May 6, 2004
PY-CEI/NRR-2796L

Perry Nuclear Power Plant
Docket No. 50-440
Response to Second Request for Additional Information Regarding License Amendment
Request to Increase Main Steam Line Turbine Building High Temperature Trip Setpoint
Allowable Value, TAC No. MC0342

The following are responses to the March 31, 2004 Nuclear Regulatory Commission (NRC) Request for Additional Information (RAI) pertaining to the August 14, 2003 (PY-CEI/NRR-2675L) Perry Nuclear Power Plant (PNPP) License Amendment Request (LAR). The subject LAR increases the Analytical Limit and the resulting Technical Specification Allowable Value related to the setpoint for the Main Steam Line Turbine Building Temperature – High system isolation function. Each specific NRC question and the corresponding PNPP response are provided below. This letter supplements the August 14, 2003 LAR and the January 22, 2004 RAI response letter.

Figure 1

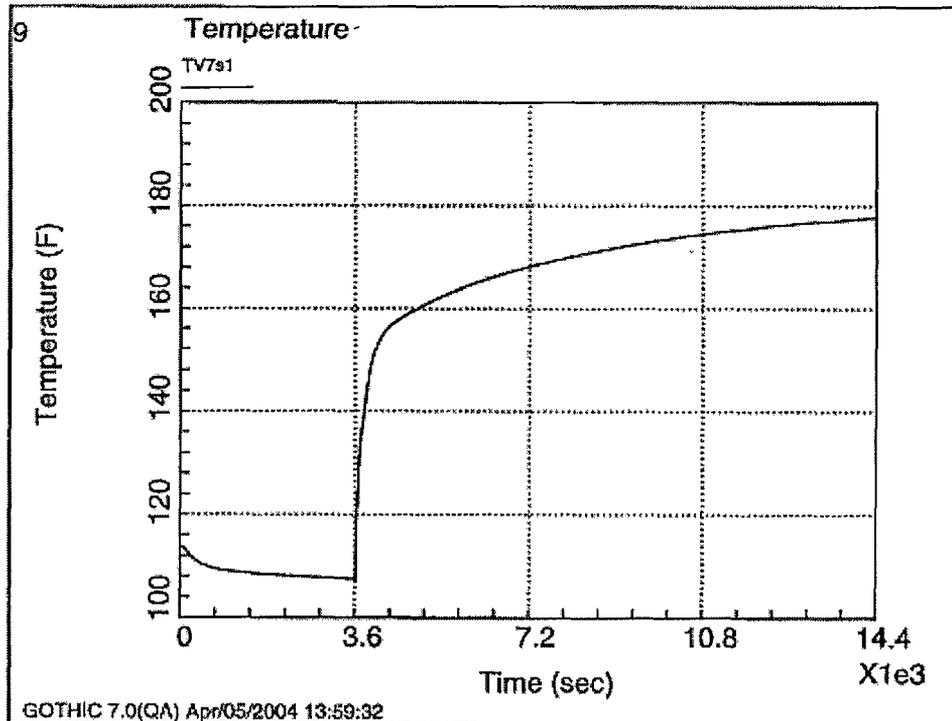
- 1) It is stated that the GOTHIC subdivided volume model is used for cases where buoyancy-induced flow is expected to be the primary means of mass transport or, for this case, when the steam line break is small and there exists the possibility of a localized temperature response (CN 2.4.6.14 Rev 0, page 3 of 51). In the GOTHIC qualification manual two studies are presented which appear to be related to this LAR. One is standard problem 13 which shows thermal stratification for a 3x3 subdivided model, however, the results are not qualified and there is only a single control volume (1,000 ft³). The other is an HDR study which supports the need for consistent vertical modeling, as used in the LAR model, however, the HDR is not on a scale similar to the turbine building. (a) Is there any data or comparisons to other computer programs (for example those used to evaluate building HVAC and contaminate transport) which can be used to assess or confirm the LAR model? (b) Have there been any “loss of ventilation” events at Perry which could be used to benchmark the model?

1a) Comparisons to other computer programs are not available; however, the following sensitivity study provides evidence to confirm the adequacy of the model. The GOTHIC model that supports the proposed LAR was originally created with the existing subdivided control volumes to determine the Turbine Building temperature response to a steam line leak of approximately 3 lb_m/s (25 gpm). The minimum steam line break flowrate was subsequently increased to approximately 33 lb_m/s (280 gpm), yet the same subdivided model was used to determine the temperature response. A larger steam flow indicates that the subdivisions may not be required since the possibility of localized temperature increase diminishes as the mass flowrate increases. To test this hypothesis, the subdivisions for Control Volume 7 were removed. Figure 1 indicates the resultant temperature.

The Analytical Limit of 155°F is reached at 587 seconds. Comparing this to the subdivided case, in which it takes 1004 seconds to reach the Analytical Limit, indicates that the subdivisions are conservative since the subdivided case takes longer to reach the temperature of interest.

Figure 2

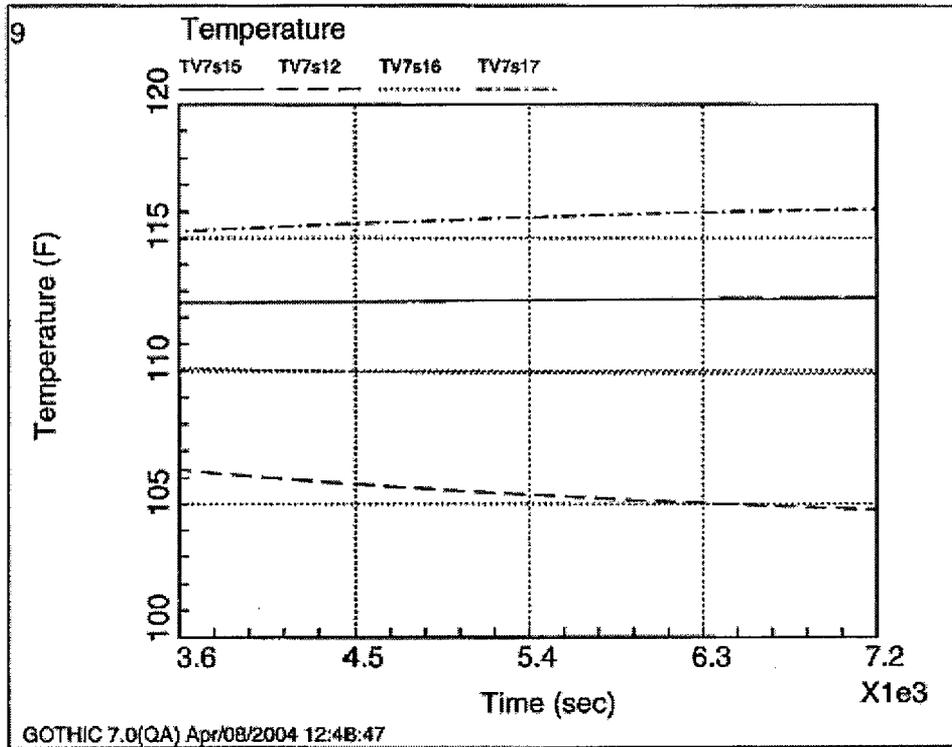
- 2) A “steady-state” run, for a period of one hour, is performed before the transient starts. During this run the “steady-state” circulation flows are established based on the initial conditions and the modeling (flow paths, heat sinks and sources). During this time period the temperatures in the model decrease, with, for example, the fluid and heat sinks in control volume (CV) 1 reaching about 84.4° F (starting at 110° F). While this could be characterized as a conservative aspect of the model, it would take longer to heat up the cooled down fluid and structures, it would appear that the results may be influenced by the nodalization. (a) Are the conditions at the end of the “steady-state” run the expected conditions at the time of the leak? (Note, for other cases, summer and average, the results are different.) (b) Have nodalization studies, changes in the number of subdivided volumes per control volume and number of control volumes, been performed to support the LAR model? (c) The heat sources and boundary conditions (fixed heat fluxes) should be re-evaluated to provide a better “steady-state,” or additional justification for the current model is needed.

- 2a,c) The steady state conditions within subvolume V7s15 (the subvolume which contains the temperature sensors) are those expected at the time of the steam leak. Figure 2 indicates several CV7 subvolume temperatures from 1 to 2 hours with no break energy entering the control volume. The temperature at the end of the steady state run for whichever case, i.e., summer, winter or average, is the same as expected at the time of the leak. The design temperature for winter conditions is 113°F and the steady state achieved by the model is about 112.5°F. Due to the subdivisions within the model, it would be virtually impossible to normalize all subvolumes at the same temperature. Therefore, a heat load was inserted which would create the desired temperature within the subvolume of interest: V7s15. Other representative subvolume temperatures are indicated on Figure 2 and, as expected, their temperature does not coincide with that of V7s15. Most importantly, however, the break subvolume (V7s12) initial temperature is 106F, which creates a conservative model since a portion of the steam break energy at the onset of the steam leak is expended on increasing the break subvolume temperature to the theoretical starting temperature rather than increasing the temperature of the sensor subvolume (V7s15). Consequently, the predicted temperature rise in the sensor subvolume is delayed because the total quantity of break energy is not immediately available to produce a temperature increase at the sensors.

Figure 3

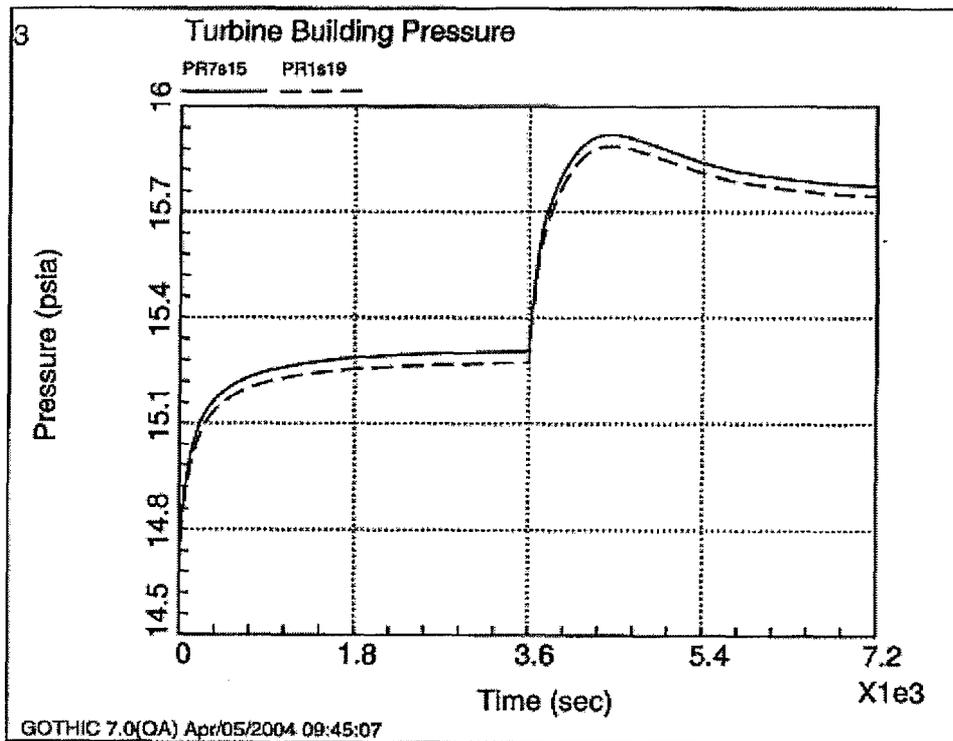
3) The intent of the environmental boundary condition, BC 1P, is to maintain the pressure in the lower elevations in the turbine building at near atmospheric pressure, with the area of flow path (FP) 21 set large enough to allow the air to be driven to the outside atmosphere. It would therefore be expected that the various CVs in the model would remain at, or near, about 14.7 psia. However, during the "steady-state" portion of the transient, the pressure rises to about 15.3 psia. Following the start of the leak the pressure increases to about 15.92 psia, in 14 minutes, and settles down to about 15.8 psia. This could be characterized as non-conservative, it would not take as long to heat up the fluid and structures at the higher pressure. (a) Are the conditions at the end of the "steady-state" run the expected conditions at the time of the leak? (Note, for other cases, summer and average, the results are different.) (b) FP21 should be re-evaluated (area, hydraulic diameter) to provide a means to maintain the pressure near atmospheric or the current model needs additional justification.

3a,b) Flowpath 21 represents the Turbine Building exhaust paths, which are provided by a series of ventilation fans. This flowpath was assigned a loss coefficient of 2.78, which created an artificial pressure increase in the Turbine Building (Figure 3).

Figure 5

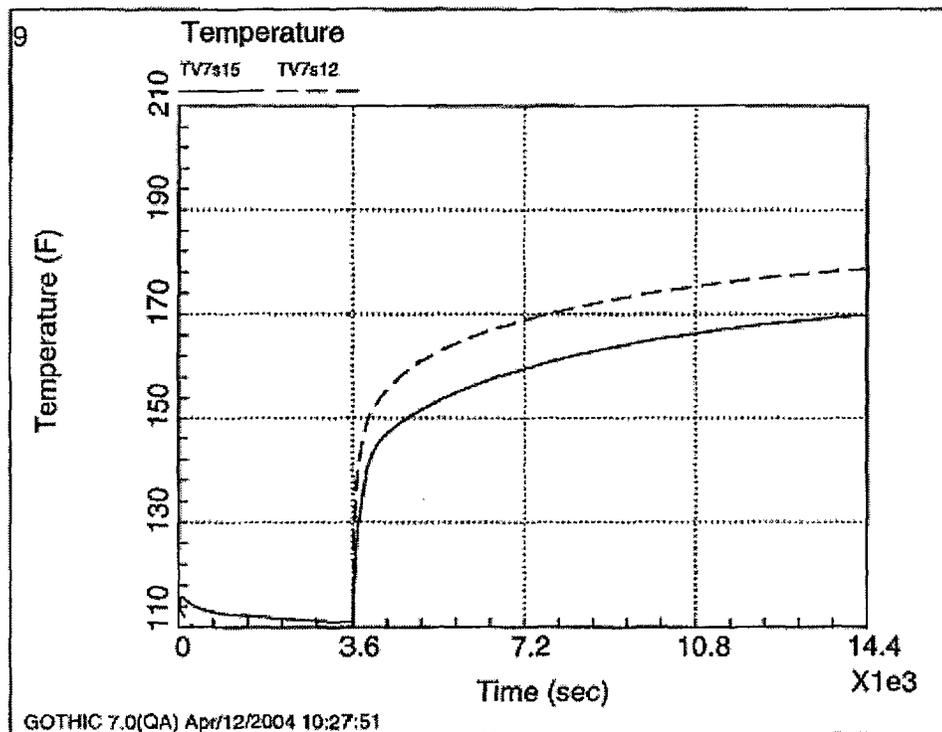
- 4) Based on guidance in the GOTHIC User Guide (for a sharp-edged orifice in a wall that is much larger than the orifice - as discussed in Section 21.6.3 "Doorways"), a forward and reverse non-recoverable loss coefficient of 2.78 is used in all FPs. It is not clear that FPs with areas on the order of 100 to 900 ft² would be covered by this guidance. The effective CV areas are on the order of 1,000 to 8,000 ft², before subdividing into smaller interfaces. Consider FP5 with an area of 915 ft², connecting CV 7s12 to CV 6s11. The subdivided volume interface area is about 1,200 ft² (39 ft by 30.5 ft), with a total side area of 8,050 ft² (115 ft by 70 ft). The total FP area between CV7 and CV6 is over 4,300 ft². (a) Provide justification for the value used for the loss coefficient, including reference to appropriate data. (b) Have any studies been performed to assess the importance of this assumption? (c) Is the geometry and forced circulation closer to the case where the value should be 1.0?

- 4b,c) The lowest value for a simple opening in a wall is 1.5, which is the combination of an entrance loss of 0.5 and an exit loss of 1.0. Although values closer to 2.78 are appropriate for many of the junctions used in this model, a sensitivity study changing all junction losses to 1.5 increases the time to 155°F from 1004 to 2147 seconds (Figure 5).

Although this is a significant increase, there are two mitigating factors. The first is that using a loss coefficient of 1.5 for all flowpaths is highly conservative and tends to be unrealistic. Most of the flowpaths will, in actuality, have a loss coefficient somewhere between 1.5 and 2.78, with some at the maximum of 2.78.

The lower resistance values increase the time to the setpoint by allowing more steam flow to the adjacent control volumes, away from the temperature sensor subvolume. The second mitigating factor is that the revised loss coefficients cause the start temperature to decrease by about 1.5°F. Adjusting the setpoint temperature accordingly to 153.5°F yields a total time to setpoint of 1796 seconds.

Figure 6

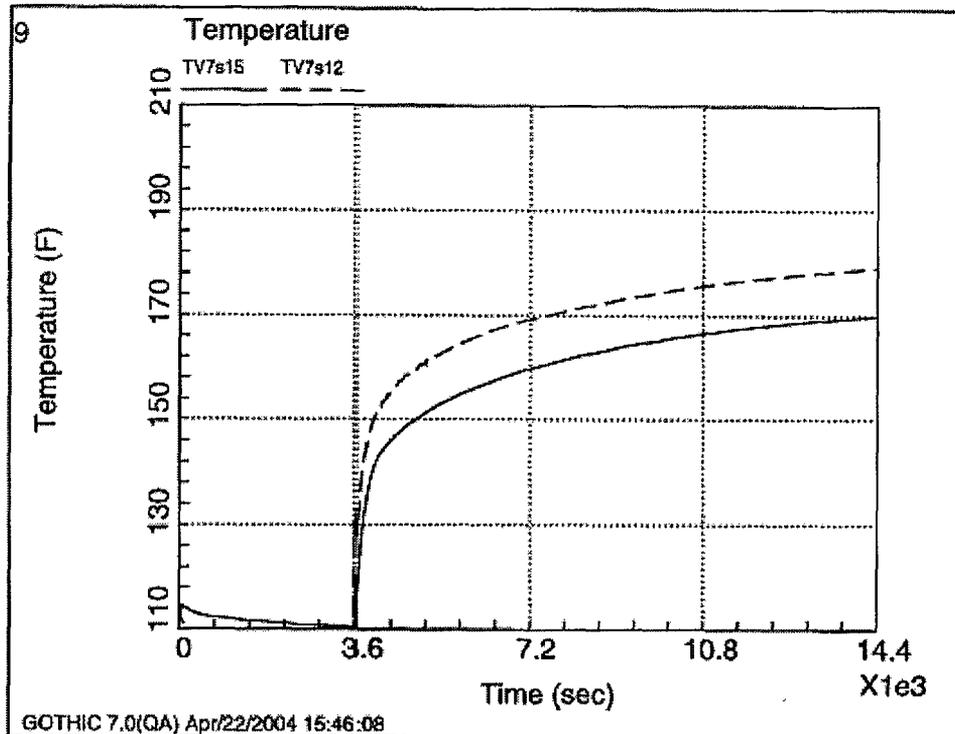
7) Scoping studies (attempting to address the above issues) performed by the staff, using GOthic 7.0, indicate that there is a large uncertainty in the time to reach the proposed high temperature trip setpoint, ranging from about 8 minutes to 48 minutes to reach 155° F. The initial and boundary conditions address seasonal changes and are reasonable. How should uncertainties in developing the model (nodalization, flow path characterization and heat sources/sinks) be considered in establishing the setpoint?

7) The previous six questions reveal some current inputs that may be considered to be nonconservative (though not necessarily incorrect). These nonconservative inputs may be evaluated by creating a file, which incorporates all of the inputs, which were determined to be more conservative. These inputs are (see the related question number for details of changes):

- Flow Path 21 loss coefficient changed from 2.78 to 0 (3b).
- All other Flow Path loss coefficients changed from 2.78 to 1.5 (4b, c).
- All Flow Path inertia lengths set to 1 foot (6a, b).
- All Flow Path hydraulic diameters set to 1 foot (6d).

These cumulative changes to the model create a time to 155°F of 2215 seconds (Figure 6), which is more than twice as long as that of the original. This result is somewhat mitigated by the slightly lower starting temperature of 110.5°F, which is 2.0°F lower than the original start temperature of 112.5°F. Adjusting the setpoint temperature accordingly (153.0°F) yields a total time of 1779 seconds.

While the sensitivity case used to investigate the cumulative effect of the nonconservative inputs results in a longer time to reach the Analytical Limit than the original analysis, the time still remains significantly less than the limiting value of 4306 seconds. The variations made to these nonconservative inputs are considered to be taken to an extreme limit of the input value and are not as realistic as the inputs used in the original model. However, the model produces acceptable results even when the values used are not representative of the analyzed configuration for those inputs categorized as nonconservative. It is concluded that the original inputs are reasonable and therefore the original model is appropriate and provides an acceptable model of the Turbine Building temperature response. However, as noted in the response to Question 3, to produce a slightly more conservative model of the Turbine Building temperature response, the original analysis will be revised to reflect the elimination of a loss coefficient for Flowpath 21.
